SUNDRY NOTICES AND REPORTS ON WELLS

Reese Mesa #8

Re: Permanent Abandonment
Well: Reese Mesa 8

CONDITIONS OF APPROVAL

Reese Mesa #8 **Proposed P&A**

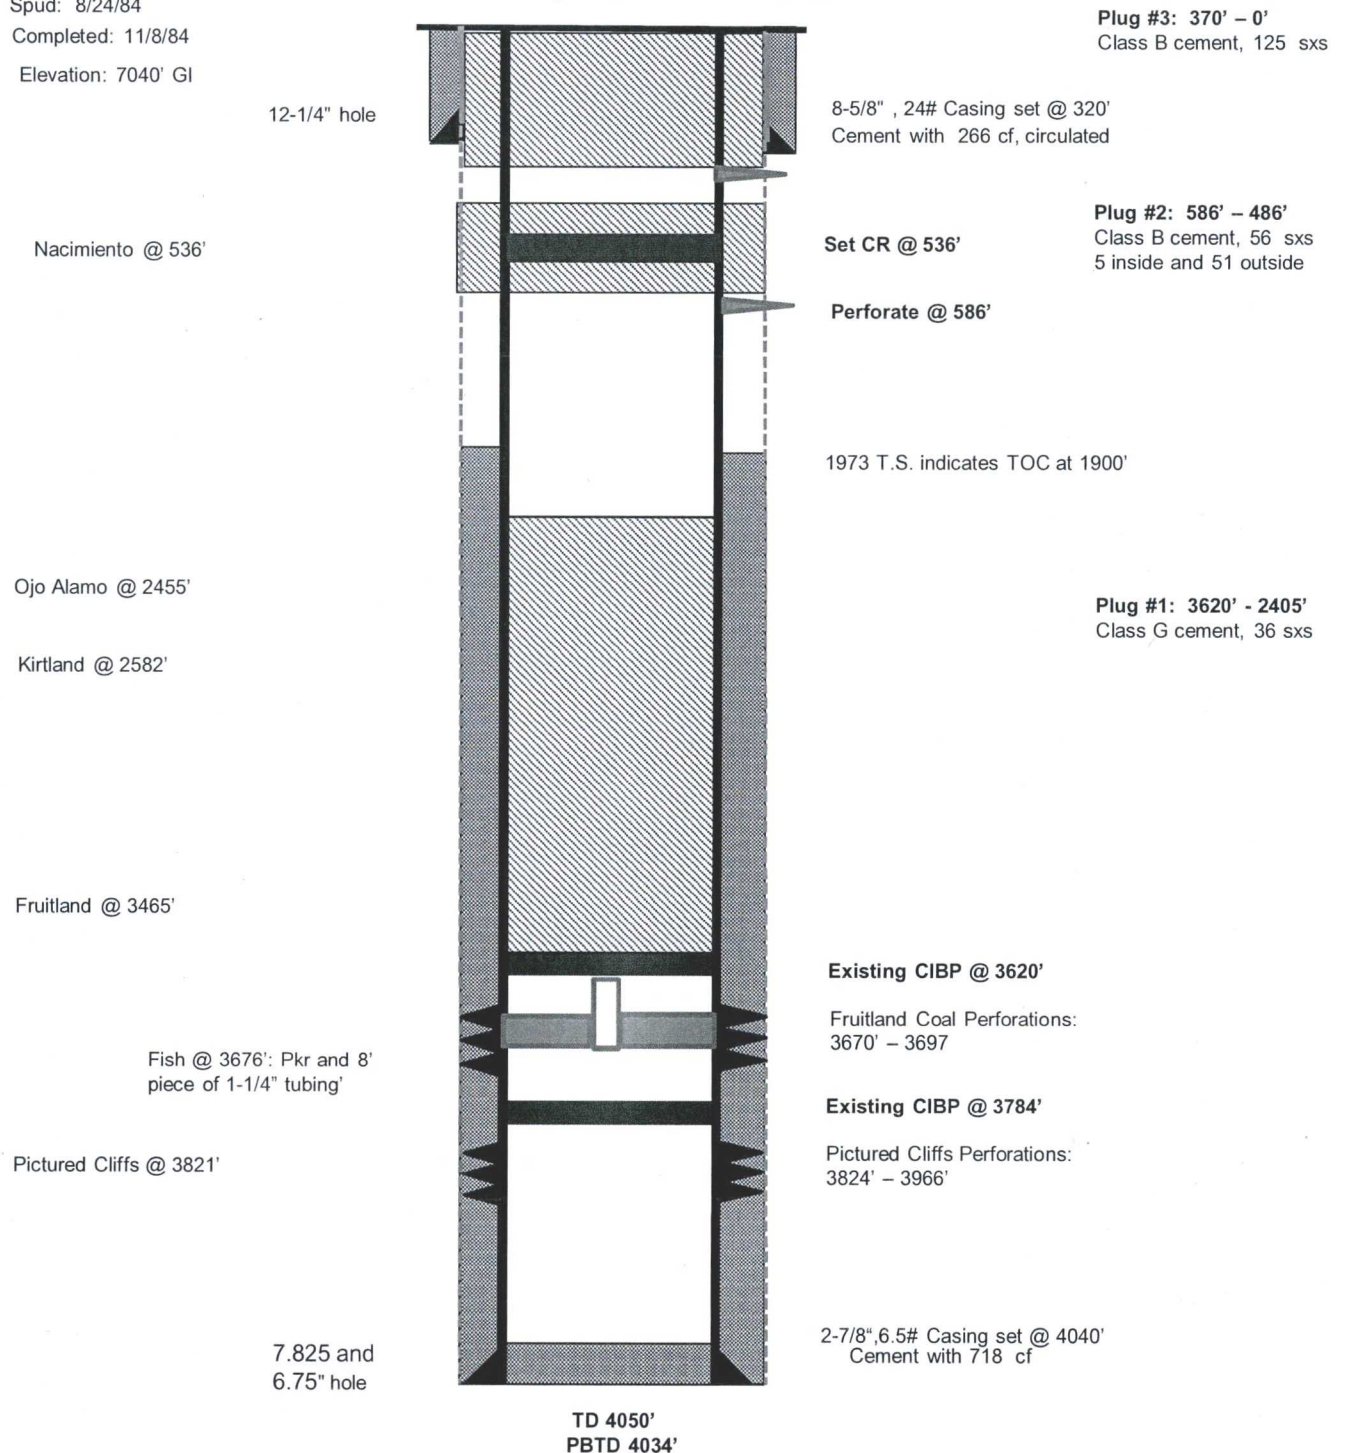
- a) Set Plug #1 (3620 – 3384) ft. to cover the Fruitland top. BLM picks top of Fruitland at 3434 ft.
- b) Set Plug #2 (2480 – 2270) ft. to cover the Kirtland and Ojo Alamo tops. BLM picks top of Kirtland at 2430 ft. BLM picks top of Ojo Alamo at 2320 ft.
- c) Add a cement plug (1031 – 931) ft. to cover the Nacimiento top. BLM picks top of Nacimiento at 981 ft.
- d) Set Plug #3 (370 – 0) ft. to cover the surface casing shoe. Casing set at 320 ft.

Operator reports **very high concentrations of H₂S (1,600 ppm GSV)** at this location. **It is imperative that H₂S monitoring and safety equipment be on location during plugging operations at this well site.**

Operator must run a CBL to verify cement top. Submit electronic copy of the log for verification to the following addresses: jwsavage@blm.gov Brandon.Powell@state.nm.us
